# SERVICE BULLETIN

ENGINE FUEL AND CONTROL — CONTROL, ELECTRONIC ENGINE (EEC) — REPLACEMENT OR MODIFICATION TO INCORPORATE SCN23/AC SOFTWARE CONFIGURATION

V2500 Series 73-0248

ATA NUMBER 73-22-34

LOCATION OF THE EEC 73-22-34 FIGURE 1

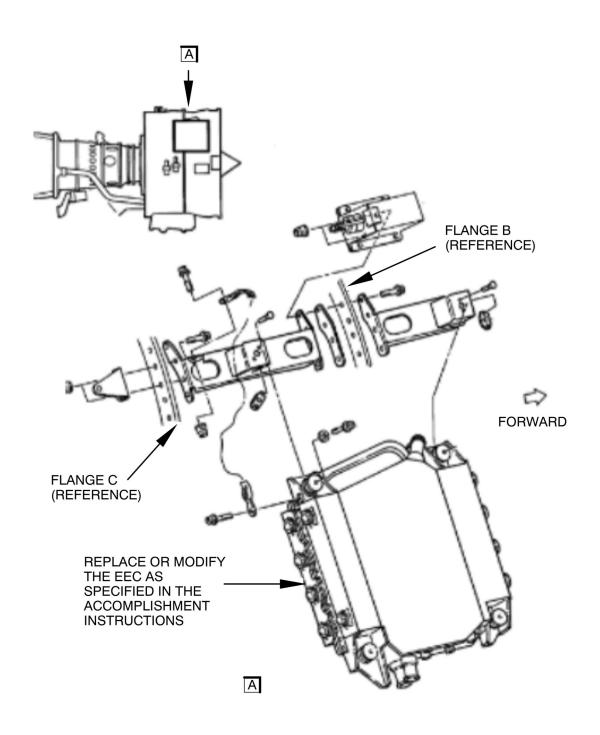
- 1. Replace or do a modification of the EEC by the procedure that follows:
  - A. Remove the EEC as specified in Reference 5, Airbus Service Bulletin A320-73-1138. See Figure 1 for the location of the part.
  - B. Replace the EEC software as given in Table 3 or do a modification of the EEC as follows. See Figure 1.
    - (1) Send the part to the vendor listed in the Vendor Services section. The modified EEC will be returned identified as given in Table 3 below.
  - C. Install the EEC as specified in Reference 5, Airbus Service Bulletin A320-73-1138. See Table 2 for old and new part numbers. Remark EEC as given in Table 3 below.

- A. Replace the EEC software as shown in Table 4 below or do a modification of the EEC as follows. See Figure 1.
  - (1) Send the part to the vendor listed in the Vendor Services section. The modified EEC will be returned identified as given in Table 4 below. Remark EEC PN as given in Table 4 below.

### PARTS PROGRESSION EEC CHART A

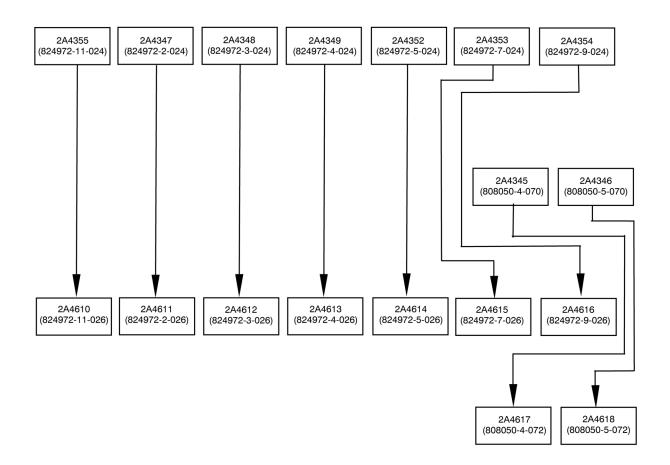
Parts Progression To Show the Changed Part in Relation to Other Parts
